CONNECTION ASSESSMENT & APPROVAL PROCESS

**Preliminary Assessment Report
For Hydro Vaughan MTS #3**

CAA ID 2000-025

January 12, 2001

Figure 1. Claireville Area Transmission Layout

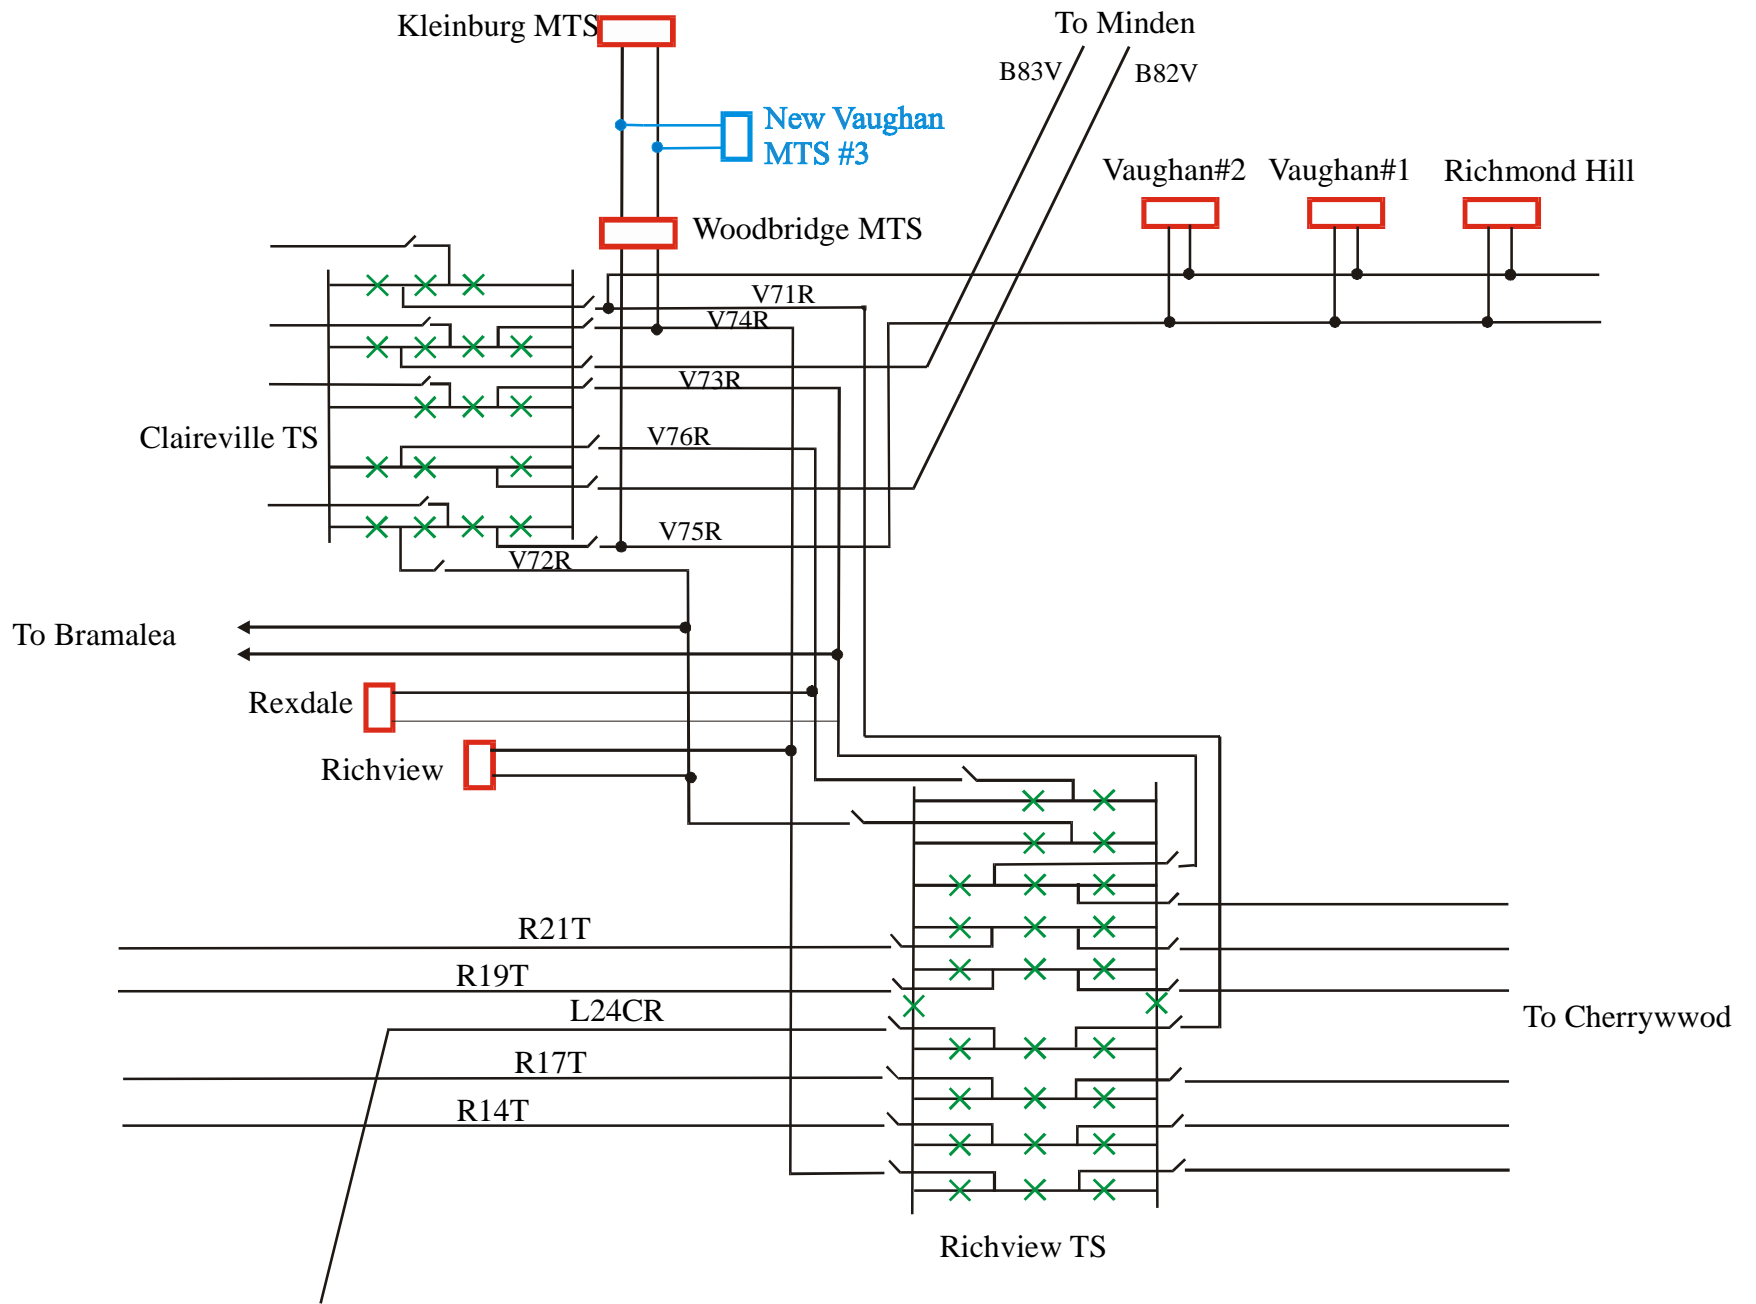
The new Vaughan MTS#3 will have a dual supply from the 230 kV single circuit lines V74R and V75R. Figure 1 shows a schematic representation of the IMO-controlled Grid in the area surrounding Claireville TS. The line designated as V75R is a radial line out of Claireville TS which branches into two sections, one going to Kleinburg and the other one going to Richmond Hill TS. The line designated as V74R also branches into two sections one terminating at Richview TS and the other one at Kleinburg. After the incorporation of the proposed development, three municipal transformer stations will be supplied via the two circuits, namely Woodbridge, Vaughan MTS#3 and Kleinburg.

Under contingency situation, for the loss of V74R or V75R the three loads will be supplied via the remaining 230 kV line. The flow on the remaining transmission line will be at about 73% of the continuous rating of the line and well under the 15-minute LTR.
